Amendments to the Drawings:

Appl. No. : 10/671,157
Amdt. dated October 17, 2005
Reply to Office Action of July 1, 2005

Remarks/Arguments

Fig. 3

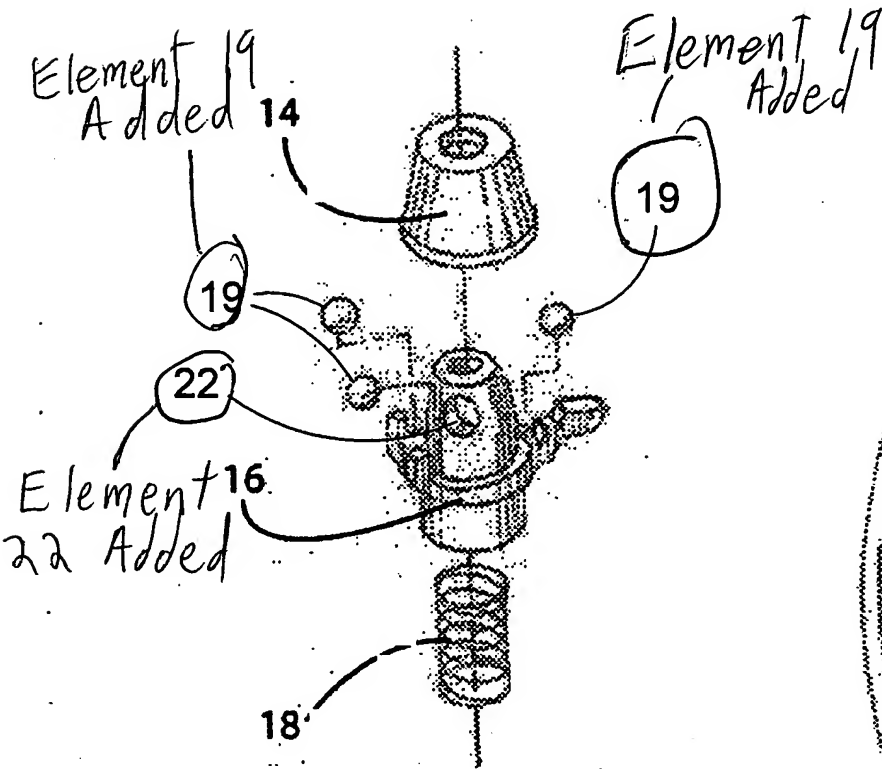
The numeral "19" was added to Fig. 3 at two places, Fig. 5 at two places, Fig. 6a at one place, Fig. 6b at two places, and Fig. 7 at two places.

The numeral "22" was added to Figures 3, 5, and 7.

The numeral "19" was added to Fig. 3 at two places, Fig. 5 at two places, Fig. 6a at one place, Fig. 6b at two places, and Fig. 7 at two places. The numeral "19" was added to identify more clearly the three ball bearings.

The numeral "22" was added to Figures 3, 5, and 7 to identify more clearly the three openings for the three ball bearings.

Fig. 6a

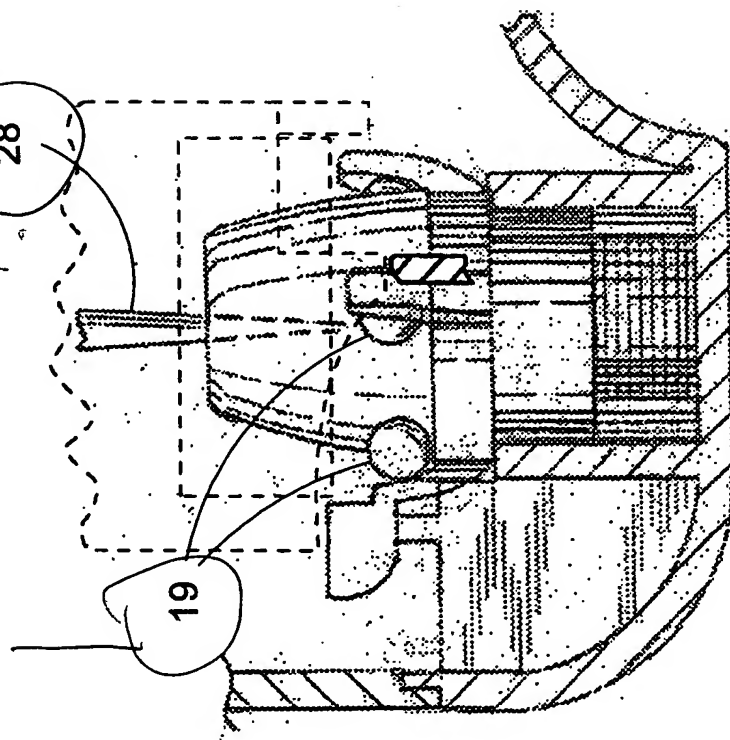
The numeral "28" was added to Figures 5, 6a, 6b, and 7.

The numeral "28" was added to Figures 5, 6a, 6b, and 7 to identify more clearly the shaft of the tack.

Element 19 Added

Element 28 Added
